Technical Service Bulletin

Subject: REAR DOOR SUNSHADE TAB LEAVES DENT IN DOOR TRIM	Bulletin No.: 09-010/17
	Last Issued: 03/17/2017

APPLICABLE MODEL(S)/VINS

2016 CX-9 vehicles with VINs lower than JM3TC*****122316 (produced before September 29, 2016)

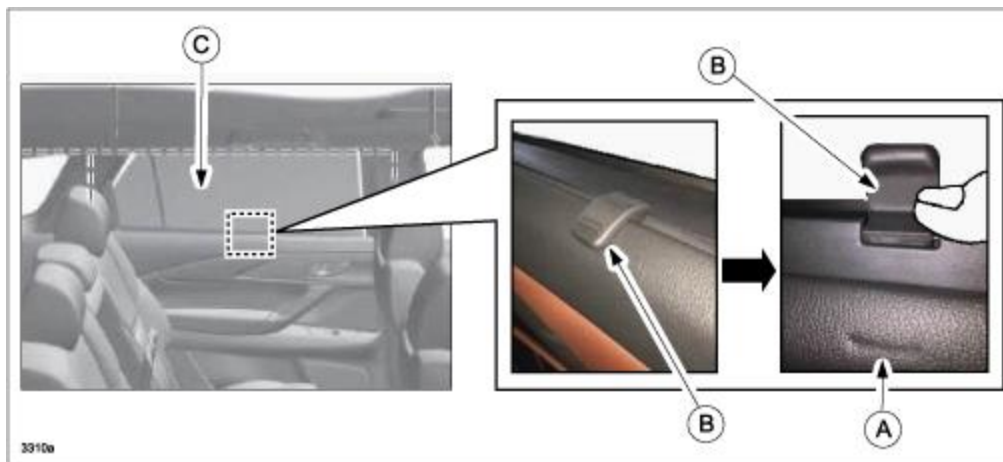
Some customers may complain about a dent (A) in the rear door trim, which is visible when the sunshade (C) is closed. The dent is caused by the sunshade tab (B) when the sunshade is opened. The tab contacts the door trim and leaves a dent.

A cushioning material (A) has been attached to the backside of tab, so the tab will no longer directly contact the trim.
